Your ref
APP/20/00470

Our ref
PLAN-034047

Proposal: Demolition of existing single storey extension and detached garage. Construction of 1no. new 2 storey dwelling house attached to the side of the existing property forming a continuation to the terrace including associated vehicular access, car parking and landscaping for both the new and existing property.

Site: APP/20/00470: - Adj to 9, St Albans Road, Havant, PO9 2JP.

Southern Water MapGuide Browser

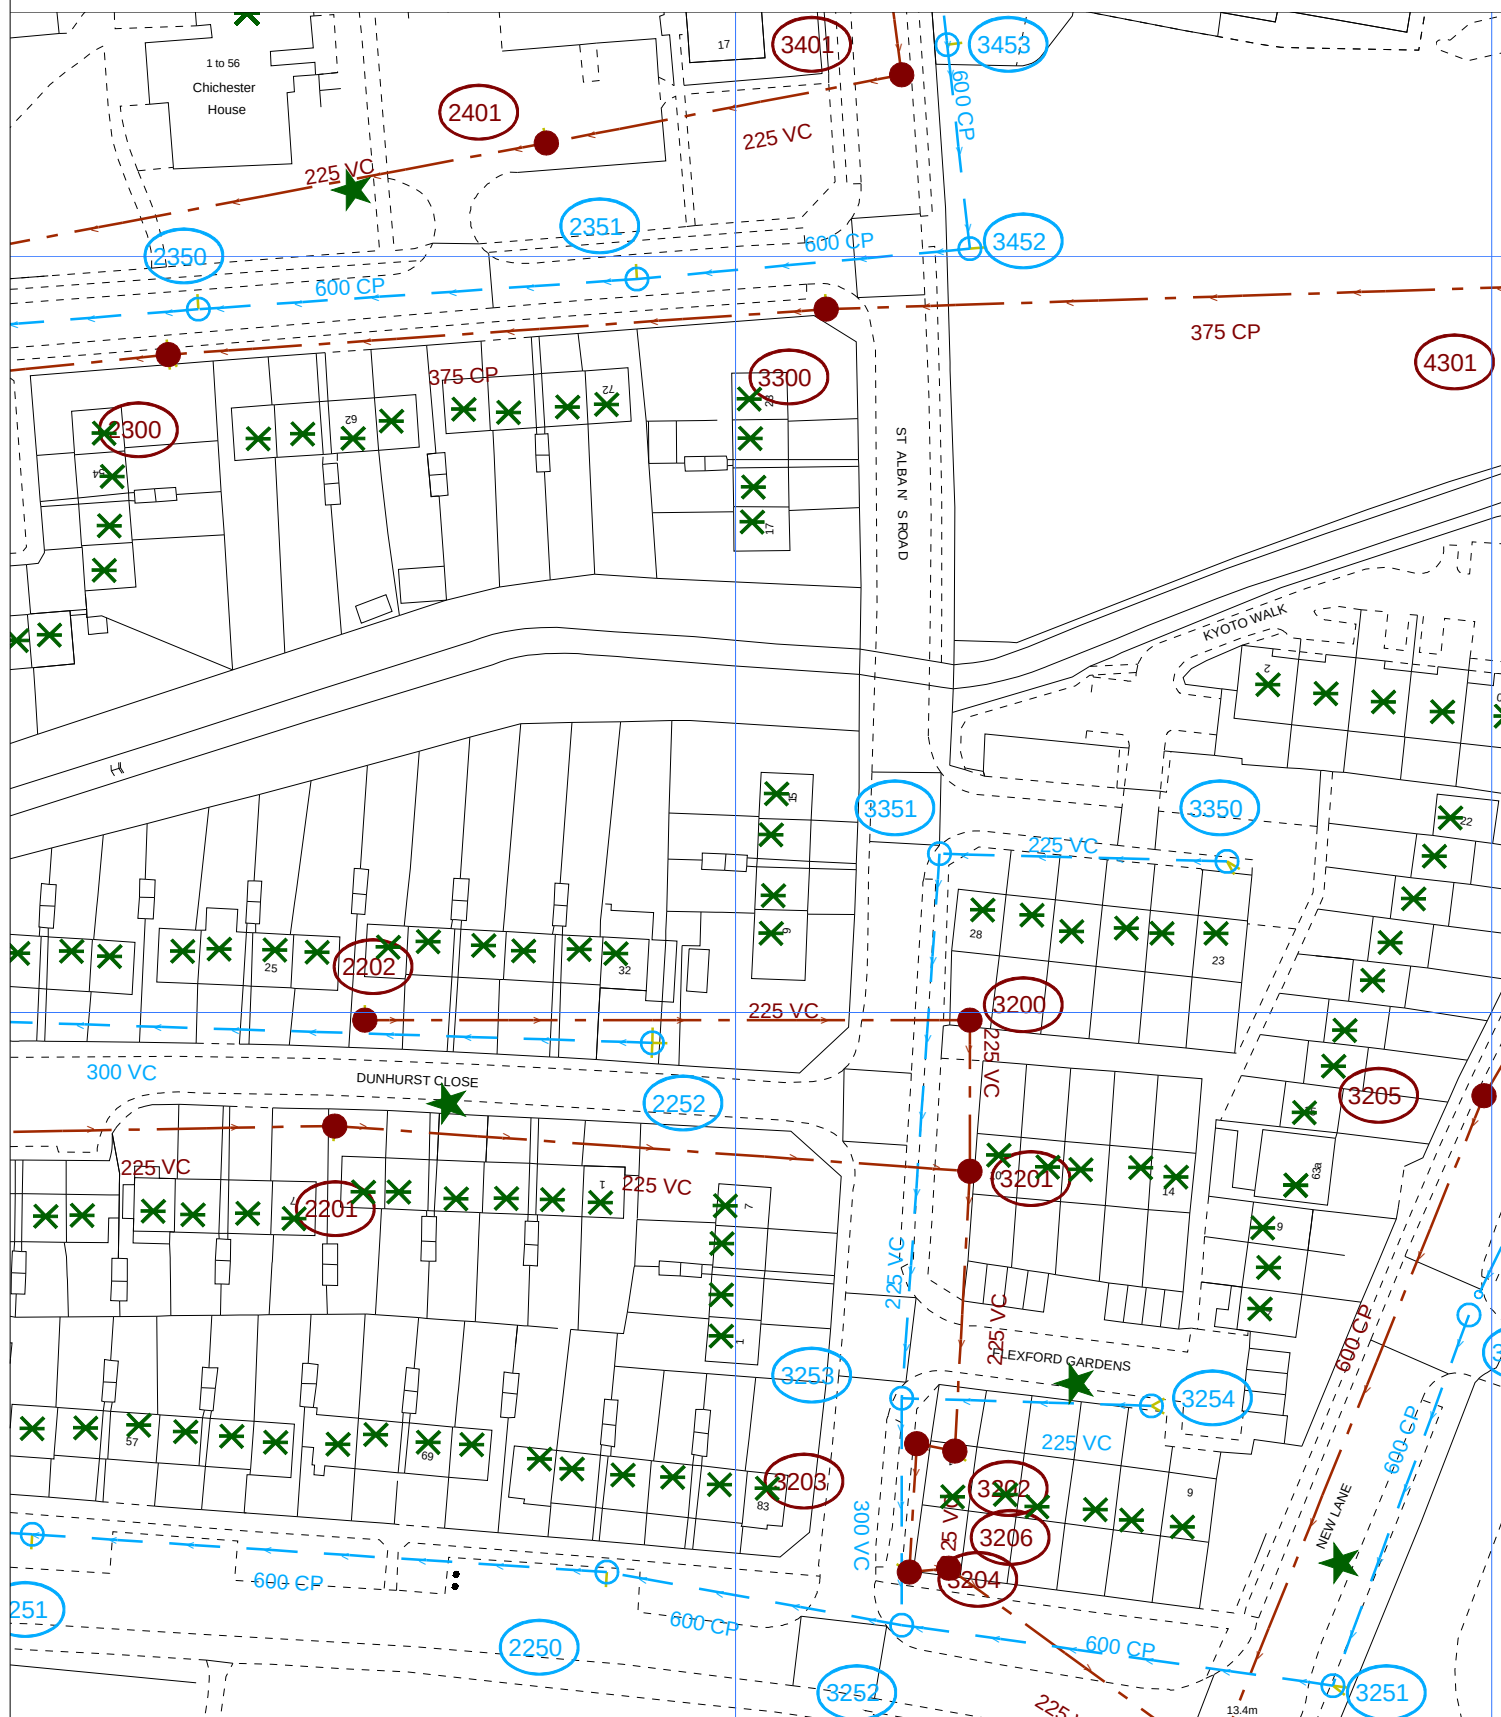
It appears that applicant is proposing to divert public sewer. Southern Water requests a formal application for sewer diversion under S185 of Water Industry Act 1991 in order to divert any public sewer.

It is possible that a sewer now deemed to be public could be crossing the development site. Therefore, should any sewer be found during construction works, an investigation of the sewer will be required to ascertain its ownership before any further works commence on site.
